ANN ARBOR PLANNING DEPARTMENT STAFF REPORT

For Planning Commission Meeting of November 1, 2016

SUBJECT: South Maple Avalon Apartments Planned Project Site Plan (1110 and 1132 South Maple Road) Project No. SP16-094

Proposed Site Layout (Eastern half):

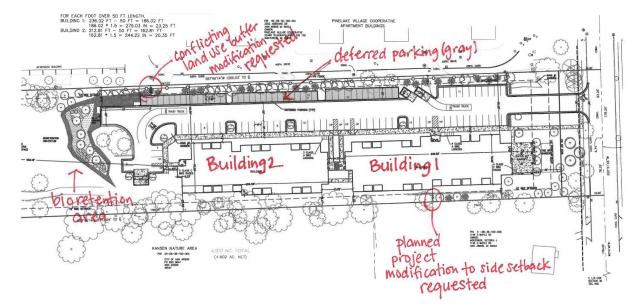
The proposed development is limited to the eastern two-thirds of the site. The proposed buildings are located on the southern half, parallel with the south property line, and a 105-space surface parking lot (of which 42 spaces, or 40%, will be deferred) is located on the north half. A single driveway will provide access to the parking lot.

The canopy over the east entrance to Building 1 meets the maximum required front setback of 40 feet in the R4B district. The proposed south side setback is 12 feet, the normal minimum standards for buildings 50 feet in length or less. However, the proposed buildings exceed 50 feet. Planned project modifications are requested to waive the additional side setback requirements.

A conflicting land use buffer is proposed along the north property line due to the parking lot. Modifications are requested to allow a reduced width for some portions of the buffer. All required plantings and the required fence will be provided; no modifications to those components of the buffer are sought.
